Subject: UniStar Nuclear Energy, NRC Docket No. 52-016
Calvert Cliffs Nuclear Power Plant, Unit 3
Supplemental Response for RAI HS-13

Supplemental Response for RAI HS-13
CCNPP Unit 3 Environmental Report

RAI HS-13 **ER Section 2.3**

Figure 4.2-1—{Final Site Grading Plan CCNPP Unit 3}

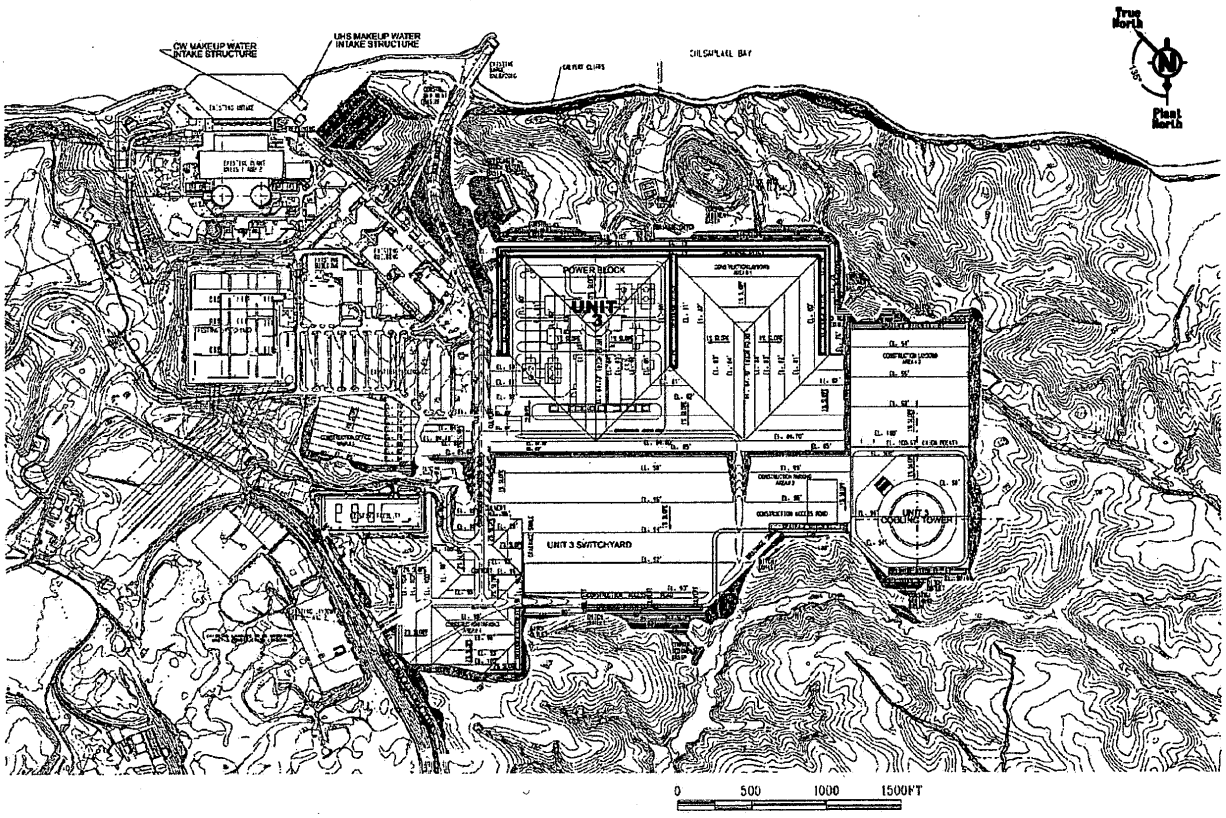
A permanent groundwater dewatering system is not anticipated to be a design feature for the CCNPP Unit 3 facilities. Removal of a portion of the Surficial aquifer during construction may eventually lower the expected depth to groundwater. Surface water controls to minimize precipitation infiltration and the redirection of surface runoff away from the facility area are expected, further minimizing water infiltration to the groundwater system beneath the site. Groundwater elevations will continue to be monitored, and any observed deviations in groundwater elevations potentially impacting the current design basis will be accounted for to design a construction dewatering system, as appropriate (Section 2.3.2.2.11 page 2.3-47). Provide if possible a topographic map with an overlay of the construction foot print and with contours that can be easily read. Describe how the recharge to the Surficial aquifer would be impacted in the short term. Long term is presented in Figures 2.3.2-(24-25). Identify how the seeps and streams would be impacted and how this would impact local wells.

The numerical model of the Surficial aquifer has been revised to evaluate construction impacts to groundwater levels in the vicinity of the power block and stream flow off site in John's Creek. Figure 2.3-86 shows the topography of the post-construction groundwater flow model and Figure 4.2-1 shows the construction footprint of the CCNPP Unit 3 site. Both stream flow and groundwater levels after construction of CCNPP Unit 3 will be dependent upon several factors, including the hydraulic conductivity of the engineered fill material used and the rate of groundwater recharge within the graded area of the site.

The numerical model of the Surficial aquifer has been revised to evaluate construction impacts to groundwater levels in the vicinity of the power block and stream flow off site in John's Creek. Figure 2.3-86 shows the topography of the post-construction groundwater flow model and Figure 4.2-1 shows the construction footprint of the CCNPP Unit 3 site. Both stream flow and groundwater levels after construction of CCNPP Unit 3 will be dependent upon several factors, including the hydraulic conductivity of the engineered fill material used and the rate of groundwater recharge within the graded area of the site.
